**FINDINGS AND RECOMMENDATION
OFFICE OF PLANNING AND ZONING
ANNE ARUNDEL COUNTY, MARYLAND**

CASE NUMBER: 2024-0195-V

REQUEST

The applicants are requesting a variance to allow a dwelling addition (second story) with less setbacks than required, with disturbance to slopes of 15% or greater, and that does not comply with the designated location of a principal structure on a waterfront lot on property located at 1156 Severnview Drive in Crownsville.

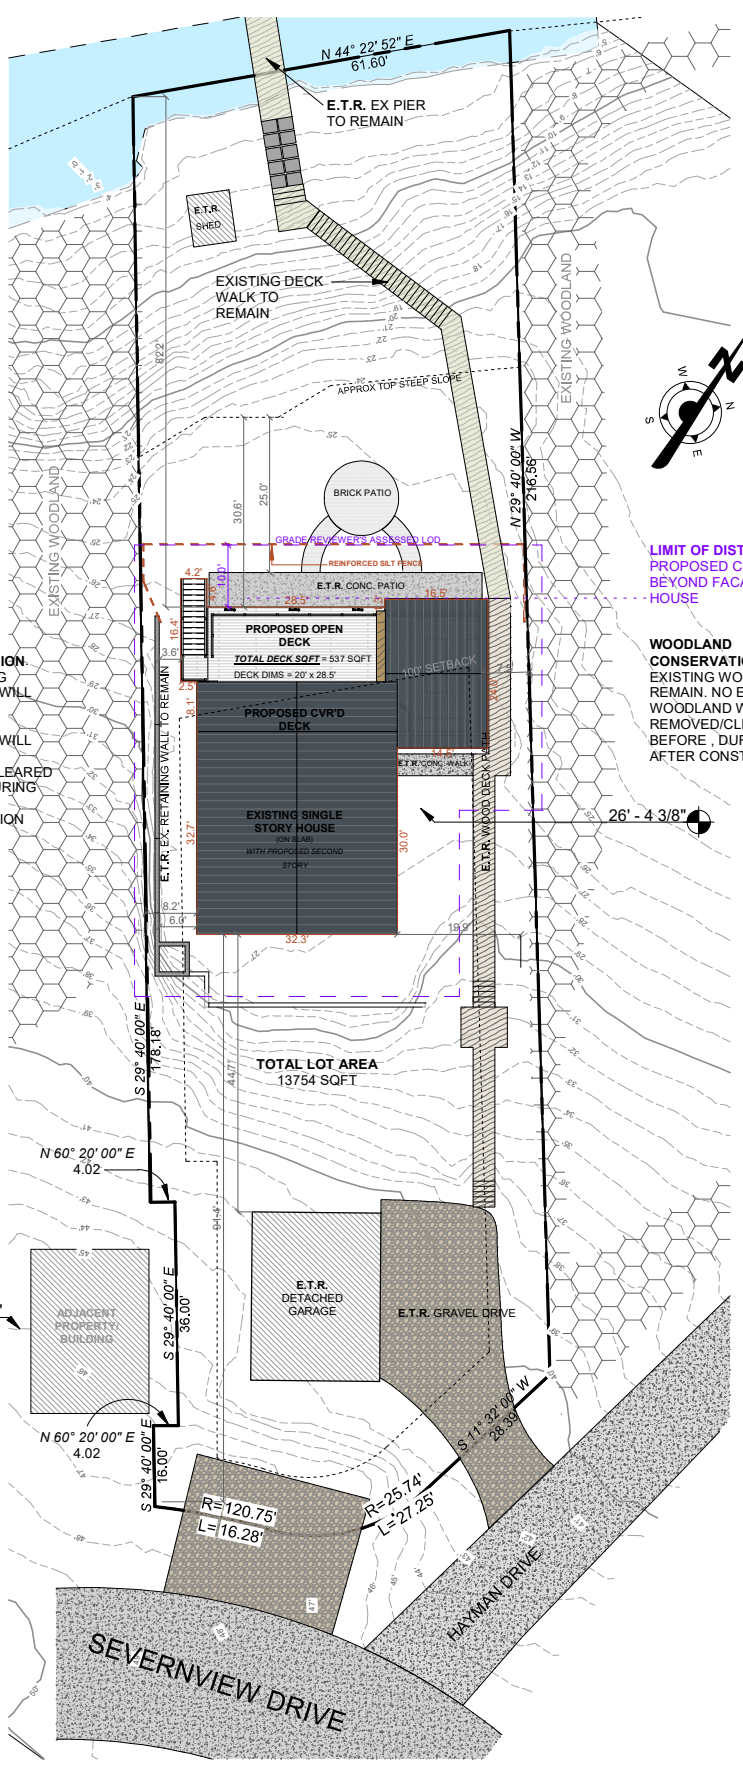
² This Office notes that the patio areas shown on the waterfront side do not match the actual conditions of the site. Not only are the semi-circular and circular patios configured differently, but there is also a larger rectangular paver patio expansion that has not been accounted for on the site plan. The expansion was constructed sometime between the January 2018 and January 2020 aerials. There is no record of a variance to allow the new critical area lot coverage nearer to the shoreline than the closest facade of the existing principal structure.
